# Ngaio cycleway audit - safety and accessibility

90% design audit

This CASA is for the 90% design stage of Wellington Transitional Cycleways, Ngaio Gorge section.

Figure 2-1: Plan showing proposed off peak parking lane and peak time cycle way

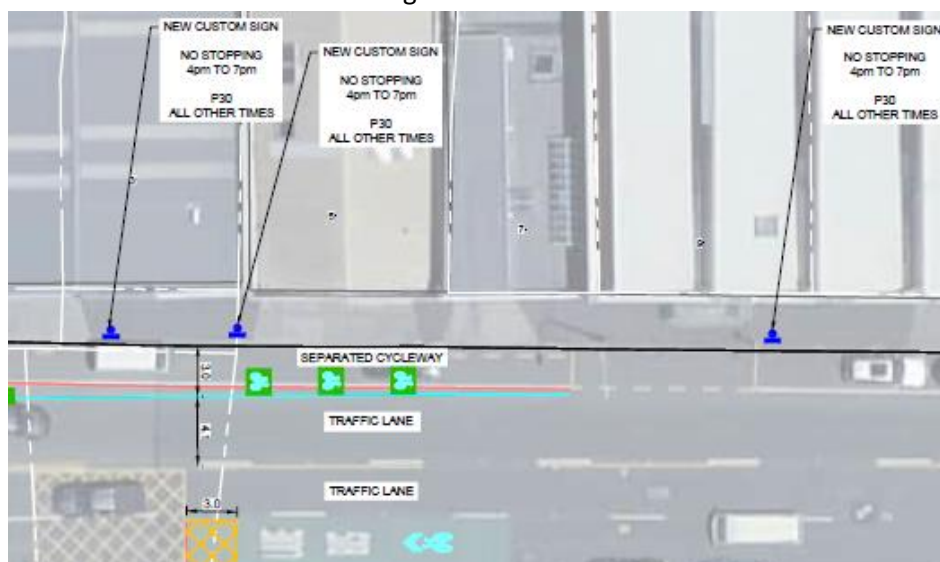
Kaiwharawhara Road is proposed to have the transitional cycleway completed over three stages, these three stages involve different level of implementation. Stage 1 restricts parking on the Ngaio bound lane during the evening peak. Outside of the evening peak the cyclists are expected to travel along the traffic lane, popping in and out of where the parking lane is occupied. The CASA does not believe this is a safe option and suggests not completing stage 1 and 2 of the implementation stages. Once able to complete Stage 3 as per the decisions report, then it is safe to do so. Cyclists travelling outside of the hours of 4-7pm will experience an unpleasant feeling of being in between the parking lane and traffic lane. The southern side of Figure 2-1 shows the shared bus lane.

2.1.1	Consider proceeding directly to stage 3
2.1.2	Provide either full time cycling facility or full-time parking facility. Do not mix both treatments.

<b>Designer</b>	Staging has been directed by WCC in response to community engagement for the project. While we agree with the CAT that Stage 3 provides the best safety improvements for cyclists, we also consider that Stages 1 and 2 provide safety improvements over the existing situation.
<b>Safety Engineer</b>	Agree with Designer. Monitor behaviour outside of pm peak and modify as necessary.
<b>Client</b>	Agree with designer. Stages 1 and 2 are an improvement.
<b>Action</b>	Continue with staged approach and add to monitoring plan.

Figure 2-2: Plan showing proposed 2.3m wide shared bus / bike lane and off peak parking lane

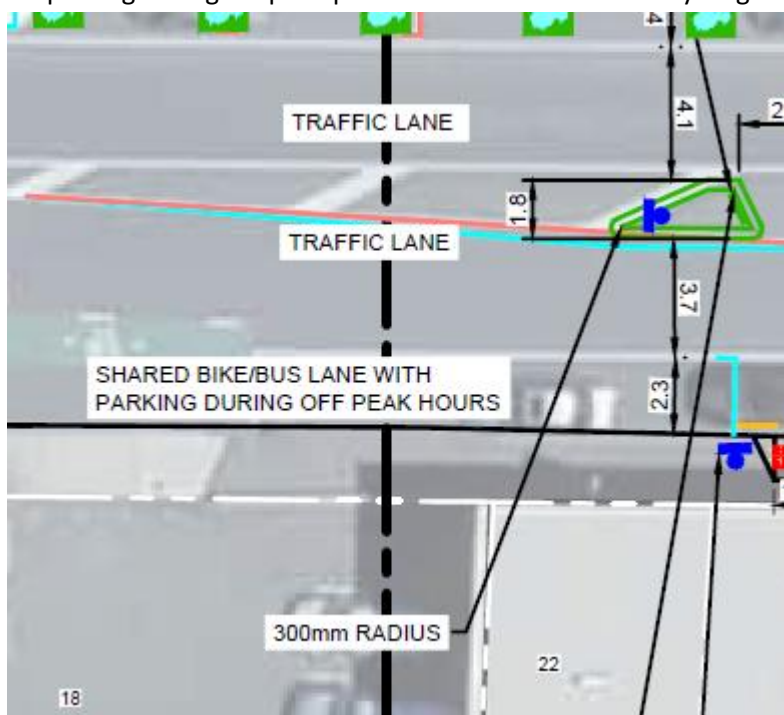
Similarly to 2.1, the shared bike / bus lane during peak hours does not align with CNG and other guidance. CNG states “Wide bus lanes can be part time, ie allow parking during non-bus lane hours. Narrow bus lanes must be permanent (ie no parking), because when parking were to be permitted, people on bikes would be forced to ride within the door opening zone. Best practice in NZ is that bus lanes should be either: wide enough for cyclists to ride adjacent to buses, 4.2 m or wider, narrow enough that cyclists and buses must travel in single file, 3.2 m or narrower.” Plans show a part-time bus lane <3.2m with parking during off-peak periods – this is not safe for cycling then.

2.2.1	Not implement stages 1 and 2 due to increased risk for cyclists. Implement only stage 3
2.2.2	Increase lane width to allow for parking and cycle facility in off peak hours

<b>Designer</b>	<p>For Recommendation 2.2.1 refer to response to Finding 2.1</p> <p>The design shows the existing bus lane markings generally being retained for Stage 1 prior to the shared bike/bus lane being increased to 4.2m wide during Stage 3. There is insufficient width to provide this 4.2m width in Stage 1 due to off-peak parking remaining on the south side of Kaiwharawhara Road. The pedestrian refuge at Cameron Street also constrains lane widths.</p>
-----------------	---

Given these constraints the length of lane less than 3.0m that could be widened to 3.2m in Stage 1 is around 70m outside 36 Kaiwharawhara Road (current shared bus/bike lane width is 2.6m). We feel this provides limited gains while introducing additional ghost markings, and recommend it is delayed until Stage 3 or when the road is resealed.
<b>Safety Engineer</b>	Agree with Designer. Monitor behaviour outside of pm peak and modify as necessary.
<b>Client</b>	Agree with designer
<b>Action</b>	Continue with staged approach and add to monitoring plan.

**Figure 2-3: Plan showing proposed extra location for wayfinding signage**

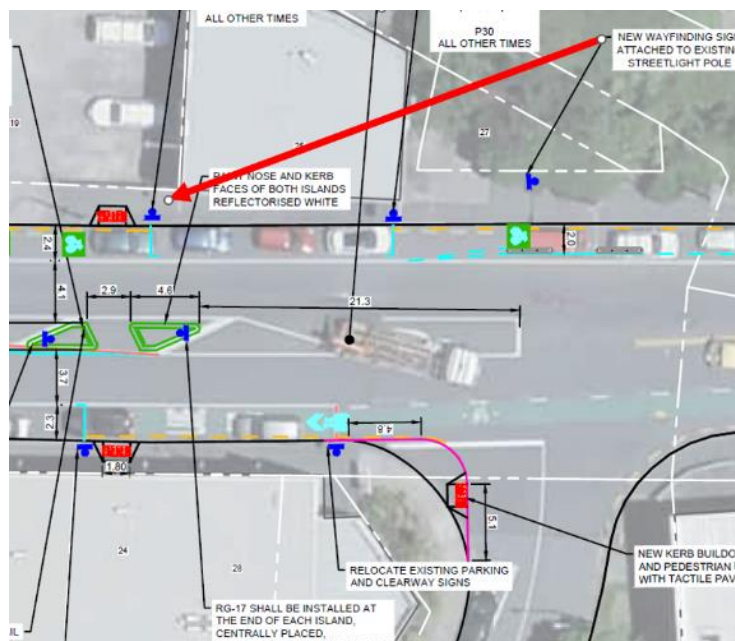
New wayfinding signage is proposed to be installed at Kaiwharawhara Road and Cameron Street intersection. Signage is proposed at the top of the intersection; a crossing point has been provided on the approach to the intersection and the CASA believes the wayfinding needs to be provided at crossing point. Cyclists using Cameron Street and following wayfinding signage are required to use the turning bay.

2.3.1 Provide wayfinding at the proposed crossing along Kaiwharawhara road.

**Designer** Agree with the CAT recommendation. This also aligns with other feedback received for the 90% design reviews.

<b>Safety Engineer</b>	Agree with CAT and Designer.
<b>Client</b>	Agree with CAT
<b>Action</b>	Provide wayfinding at proposed crossing

Figure 2-4: Plan showing road marking option for speed repeaters along Cameron Street

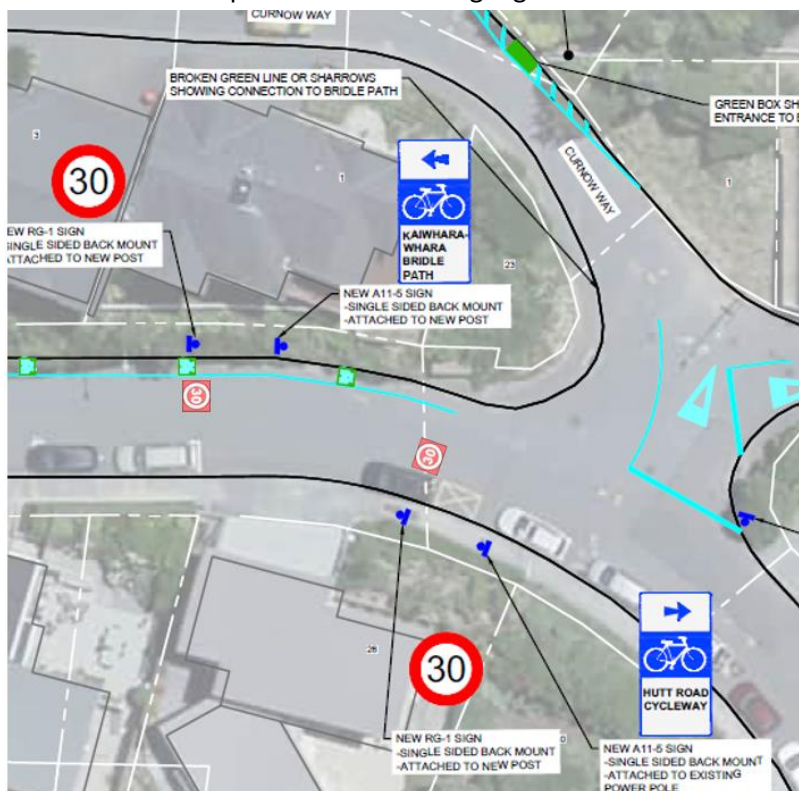
Cameron Street is proposed to have a speed reduction to 30 km/h. Repeat signage is proposed throughout the length of Cameron Street. The *Setting of speed limits 2022 Rule* no longer requires repeaters to be installed on speeds other than 50 km/h and 100 km/h. The CASA ponders the use of road marking at the locations for repeaters instead of signage.

2.4.1 Consider the use of road marking for speed repeaters.

<b>Designer</b>	<p>Agree with the CAT recommendation.</p> <p>A general theme identified across all feedback received for the 90% design is a desire to reduce the number of signs and reduce clutter in the road environment which aligns well with this recommendation.</p>
<b>Safety Engineer</b>	Agree with CAT and Designer.
<b>Client</b>	Agree with CAT
<b>Action</b>	Use road markings rather than signs for speed repeaters

Figure 2-5: Plan showing proposed intersection kerb changes

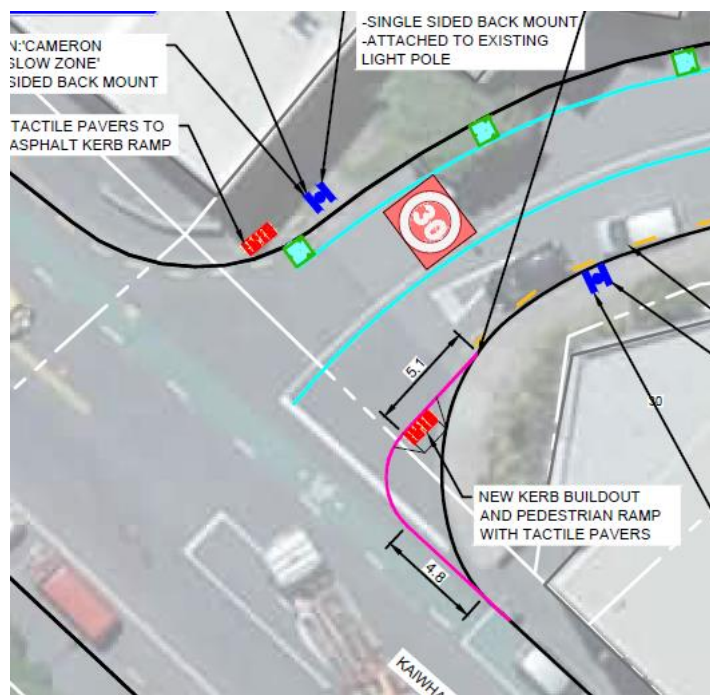
Cameron Street is proposed to have kerb build-outs installed on the downhill lane. The CASA believes kerb build-outs should be completed on both sides of the road. Reducing the radius of both corners will help reduce the speed into and out of Cameron Street. The pedestrian ramp is proposed within one car length from the give way limit line. The CASA suggests putting the pedestrian ramp one car length back from the limit line. This will allow vehicles to be parked at the limit line and pedestrians to still cross.

2.5.1	Install kerb build-outs on both sides of Cameron Street
2.5.2	Provide pedestrians a crossing location while one vehicle is stopped at the limit line.

<b>Designer</b>	<p>The transitional cycleway approach is to minimise physical works. The kerb buildout proposed is considered beneficial to control exit speeds from Cameron Street.</p> <p>The footpath along Kaiwharawhara Road to the north side of Cameron Street ends at the existing pedestrian ramp. A kerb buildout or changes to extend the footpath and provide a new kerb ramp on the north side of Cameron Street is considered beyond our current scope.</p> <p>The pedestrian ramp on the south side of Cameron Street has been aligned with the existing ramp on the north side. This location also provides good visibility along Kaiwharawhara Road in either direction and aligns with the pedestrian desire line. On</p>
-----------------	---

this basis we consider that the design location for the pedestrian ramp provides the best outcome
<b>Safety Engineer</b>	Agree with Designer.
<b>Client</b>	Agree with designer. There is a kerb ramp and this is out of scope.
<b>Action</b>	No change to plans.

**Figure 2-6: 1 Cameron Street parking location**

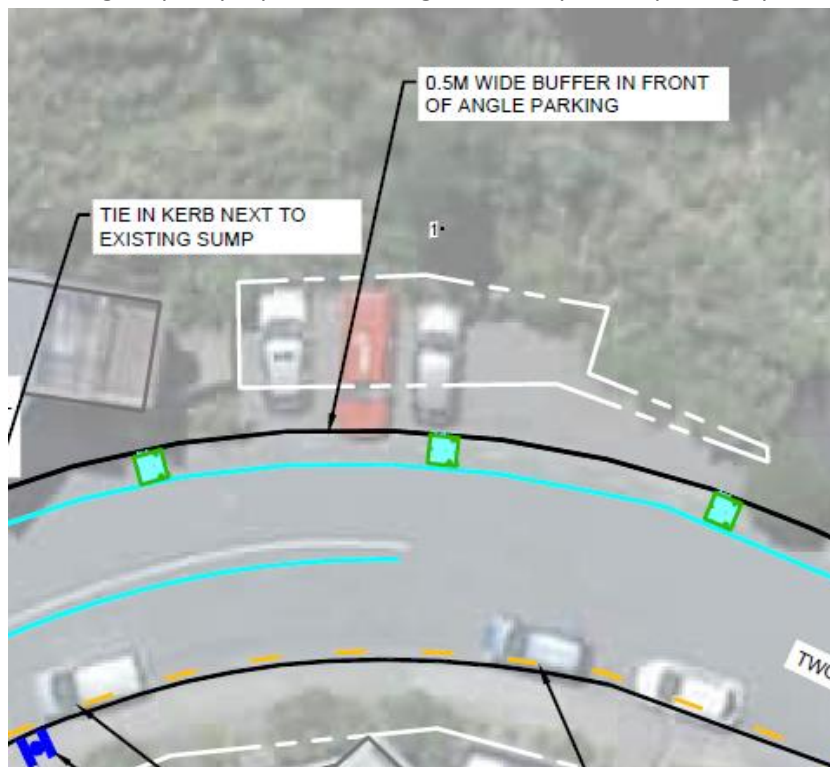
We agree with the design report proposal to change these to parallel parking spaces.

2.6.1      Reconfigure parking bay to parallel spaces as per design report.

**Designer**      Client direction required to confirm if a change to parallel parking as described in Section 2.3 of the design decisions report can be implemented within this project’s scope.

**Safety Engineer**      Agree with the change to parallel parking.

<b>Client</b>	Agree with Safety Engineer.
<b>Action</b>	Change the angle parking to parallel parking.

Figure 2-7: 1 Fore Street access signage

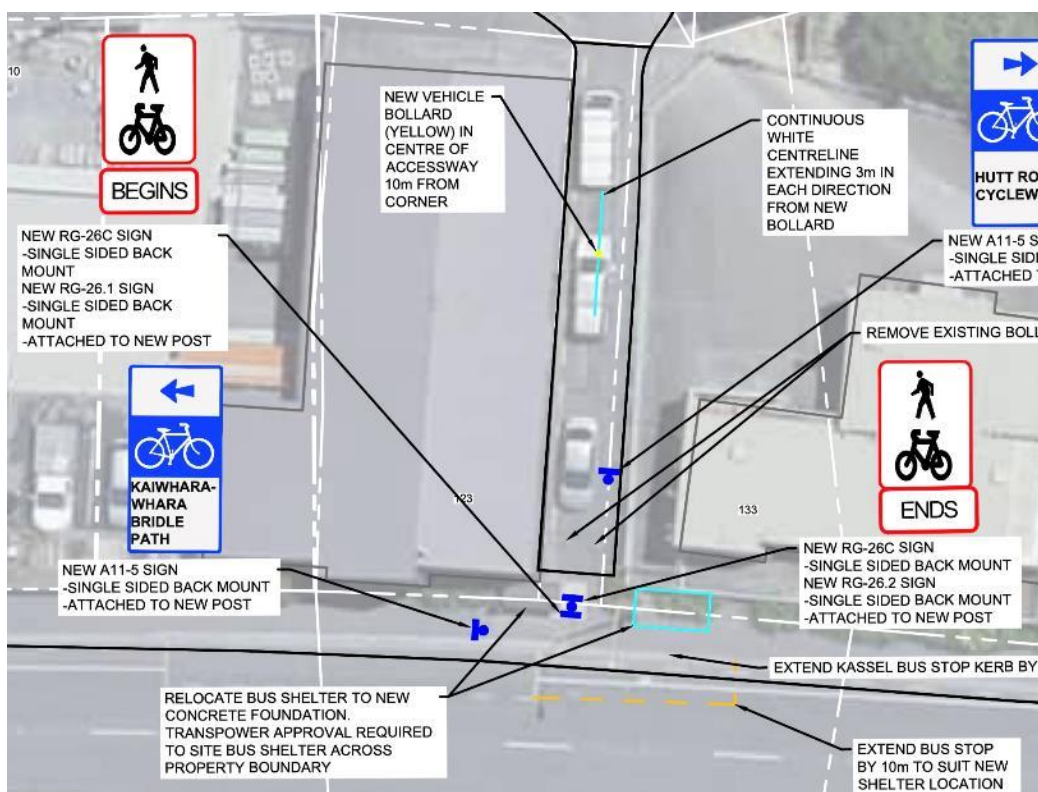
Sheet 3 has several issues:

- The central bollard should be carefully designed as per [Access control devices on paths](#). For example, the height of the bollard is not specified. For riders who are following other riders, they may not see the bollard until it is too late. The bollard is specified to be 10 m from the corner; however, this would permit up to two vehicles to park in the pathway - why not shift the bollard closer to Pickering Street. *The placement and height of the bollard (if less than a rider height) may occasionally cause a crash resulting in likely serious injury.*

- The “shared path begins and ends” signage may be placed there as an additional vehicle access control method; however, there is a full height kerb at the Hutt Road end. The sign is not technically required, and path markings would reduce cost and sign clutter, as well as make it easier to negotiate the corner.

- There does not seem to be provision to cross the full height kerb to access the Hutt Road cycleway. *The full height kerb may occasionally result in riders falling while trying to mount it, resulting in minor injury.*

- The Hutt Road Cycleway sign has the arrow pointing the wrong direction for the majority of the route; preferably this would be a dual headed arrow.
- The bus shelter appears to be placed in conflict with the existing streetlight pole and should be indicated slightly further from the Fore Street path.

2.7.1	Increase height of central bollard on Fore Street and/or length of line markings with lane direction arrows to reduce chance of riders striking the bollard
2.7.2	Consider shifting the bollard closer to Pickering Street to minimise parking in the pathway
2.7.3	Consider need for and placement of the shared path sign at the Hutt Road end of Fore Street
2.7.4	Consider how riders will enter/exit Fore Street from Hutt Road – there does not appear to be any kerb ramp (or plan for a temporary one)
2.7.5	Add a dual head arrow to the Hutt Road Cycleway sign
2.7.6	Shift the bus shelter to not conflict with the street light pole

<b>Designer</b>	<p>2.7.1 Agree with CAT recommendation. This also aligns with other feedback received for the 90% design reviews. We suggest extending the line markings aligns best with the feedback received.</p> <p>2.7.2 The bollard was located part way down Fore Street to improve the length of lead in for cyclists and provide a T turning area for industrial lanes as shown in Plan R-9-706 in the WCC Code of Practice for Land Development. This also links to Recommendation 2.7.1 (extended markings shouldn't extend across Pickering Street). The distance from Pickering Street could be reduced to 5.5m if WCC accept a turning area for residential streets instead</p> <p>2.7.3 A general theme identified across all feedback received for the 90% design is a desire to reduce the number of signs and reduce clutter in the road environment which aligns well with this recommendation. Design can be updated to show markings rather than a sign</p> <p>2.7.4 &amp; 2.7.5 The footpath along Hutt Road ends just beyond Fore Street, and there is no crossing facility for cyclists or pedestrians across the four lane wide Hutt Road. All users are required to divert approximately 75m to the signalised crossing at Kaiwharawhara Road. We note that the majority of cyclists are travelling south towards the city resulting in minimal delay.</p> <p>2.7.6 Agree with CAT recommendation</p>

<b>Safety Engineer</b>	<p>Agree with Designer's responses.</p> <p>Ensure adequate wayfinding signage to the signalised crossing at Kaiwharawhara Road.</p>
<b>Client</b>	<p>As the footpath along the Hutt Road is too narrow for too long to be a shared path, the Fore Street option should be removed from the plans.</p>
<b>Action</b>	<p>Remove Fore Street option from the plans, and therefore no other action required.</p>

Figure 2-8: Cameron / Pickering Street shared path map marked up with proposed locations for signage

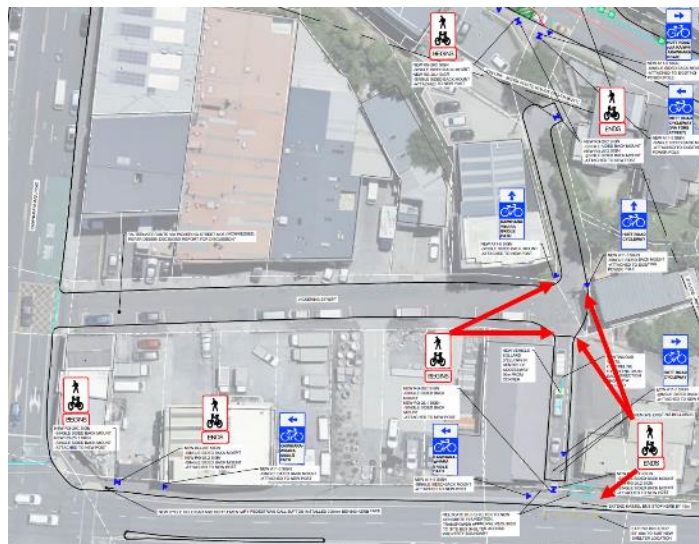
Proposed shared path signage needs reviewing. Figure 2-8 shows the extents of shared path requiring signage to demarcate the start and end of shared path.

2.8.1 Revise general arrangement plan sheet 3 to include more “begins” and “ends” signage.

<b>Designer</b>	A general theme identified across all feedback received for the 90% design is a desire to reduce the number of signs and reduce clutter in the road environment. This will result in changes to replace some or all of these signs with markings.
<b>Safety Engineer</b>	Agree with Designer.
<b>Client</b>	Agree with designer, however, this section is to be removed from plans.
<b>Action</b>	Remove signs at Cameron/Pickering streets.

Figure 2-9: Insert of plan showing entry into alternative route

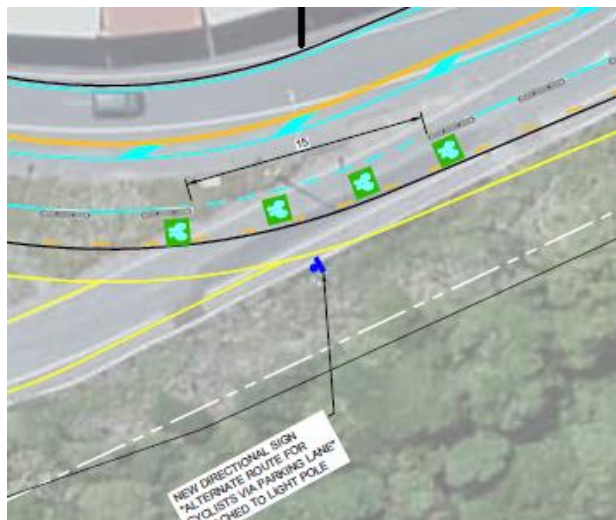
The location of wayfinding signage for the alternative route up Ngaio Gorge diagrammatically looks to be away from the line of sight of uphill cyclists. The CAT suggests moving the alternative route sign to the decision point upstream.

2.9.1	Consider moving the alternative route sign upstream to the decision point upstream
<b>Responses</b>	
<b>Designer</b>	Agree with the CAT
<b>Safety Engineer</b>	Agree with CAT and Designer.
<b>Client</b>	Agree.
<b>Action</b>	Move the sign.

Figure 2-10: sheet 5 extract highlighting narrow cycle lane

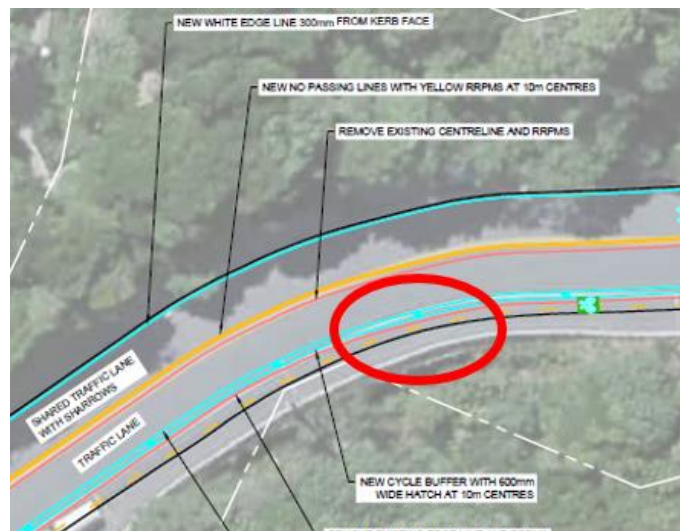
A section of the cycle lane uphill on Ngaio Gorge Road shows very narrow lane on the inside of a bend. The CAT suggests altering the type of buffer to allow more space for cycling.

2.11.1	Investigate the layout through the corner to determine if the cycle lane width can be increased.
--------	--

<b>Designer</b>	The lane and edge lines have been set to achieve vehicle tracking. Increasing the cycle lane width in this location would require buses and other vehicles to track across the cycle lane or centreline around this corner.
-----------------	---

<p>The buffer is painted and has ATP markings, so should not unnecessarily constrain cyclists.</p> <p>We recommend additional green cycle blocks around each corner to further highlight the cycle lane.</p>
<b>Safety Engineer</b>	Agree with Designer.
<b>Client</b>	Agree with designer.
<b>Action</b>	Add green blocks around this corner.

Figure 2-13: Ngaio Gorge Road sheet 8 extract

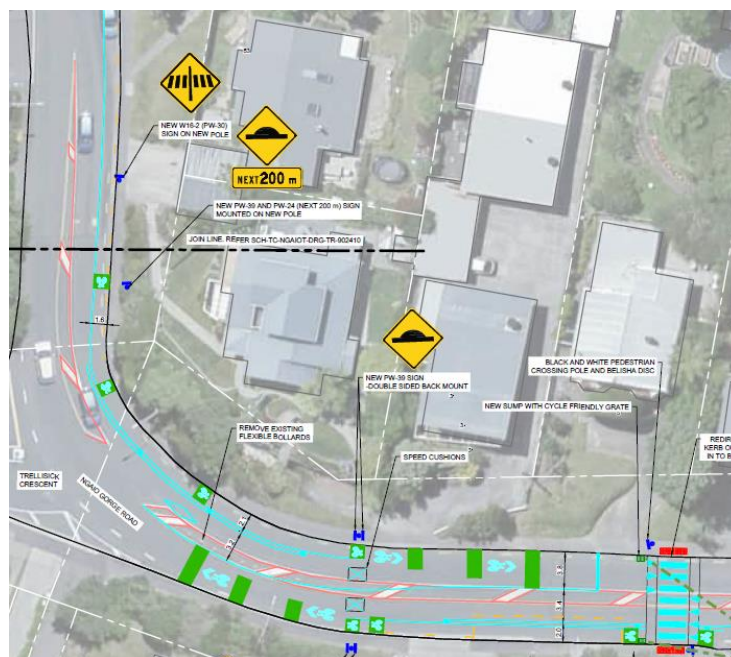
The TCD manual doesn't allow for the use of PW-24 (NEXT xxx m) supplementary signs on a PW-39 hump sign. In discussions with Waka Kotahi, the CAT team has been informed that a single PW-39 sign preceding the first speed management device is sufficient if the devices are closely spaced. No advisory speed (PW-25) has been provided for the PW-39. PW-25 are allowable in the TCD manual and may be considered.

The pedestrian crossing PW-30 sign is located before the speed cushion signage. Between the distance of this sign to the crossing and the plethora of signs, the CAT considers that drivers may not remember the key message (pedestrian crossing ahead). The CAT recommends that it is shifted to the position of the first hump sign, and that there be only one hump sign at the cushion.

2.13.1	Consider moving the PW-30 pedestrian crossing sign to the position where the first speed hump sign is currently proposed
2.13.2	Retain only one PW-39 hump sign adjacent to the cushion and supplement it with an advisory speed applicable to the cushion and the RSP pedestrian crossing.

<b>Designer</b>	Agree with the CAT recommendation.
	A general theme identified across all feedback received for the 90% design is a desire to reduce the number of signs and reduce clutter in the road environment which aligns well with this recommendation.
<b>Safety Engineer</b>	Agree with CAT and Designer.
<b>Client</b>	Agree.
<b>Action</b>	Move signs and add speed advisory sign.

Figure 2-14: Ngaio Gorge Road General arrangement plan sheet 8 extract

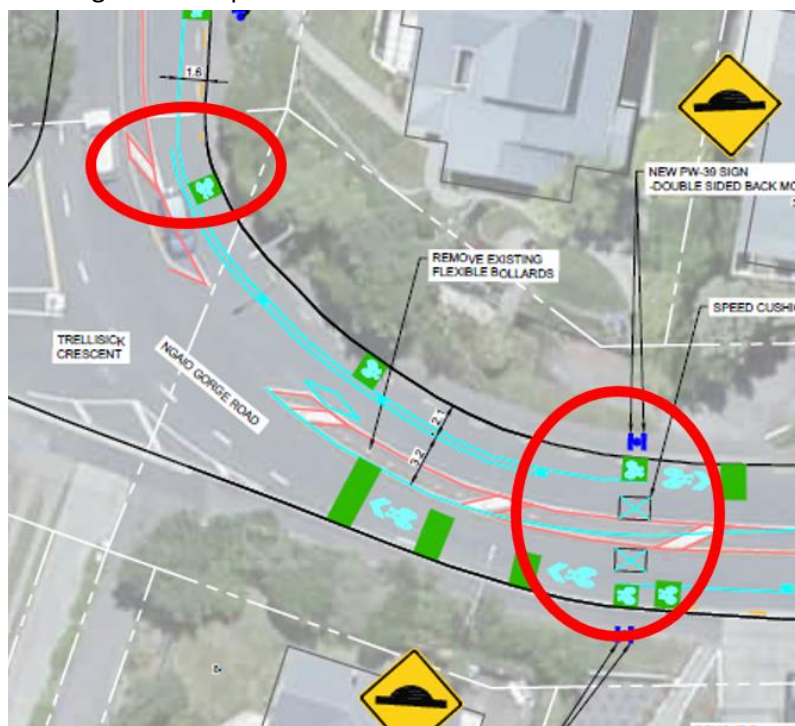
90% design plans show cycleway buffer to start at the start of a bend and stop early of speed cushions. The CAT ponders the need for starting the buffer in the bend and not on the approach to the bend. The exit of the buffer before the speed cushions diagrammatically looks to create an easy path for vehicles to skip travelling over the speed cushions.

2.14.1 Increase the use of cycle way buffer on the approach and exit.

**Designer** Feedback received for the 90% design recommended extending the buffer along Kenya Street which will be updated on the plans.

Feedback also recommended that the speed cushions are changed to speed humps. Providing speed humps across the full width of the carriageway will address the CAT finding regarding vehicles trying to skip around the speed cushions.

With regard to the markings the width is very constrained in this section, with the combined traffic and cycle lane width in each direction at the speed cushions only 4.4m. Extending the buffer would reduce the cycle lane to 1.0m wide, although we note that the buffer is flush and rideable so wouldn't constrain cyclists. We recommend the

markings stay as shown with the addition of a taper line from the buffer back to the cycle lane.
<b>Safety Engineer</b>	Agree with Designer.
<b>Client</b>	Agree with designer.
<b>Action</b>	Extend cycle lane past Trelissick Cres, change speed cushions to humps.
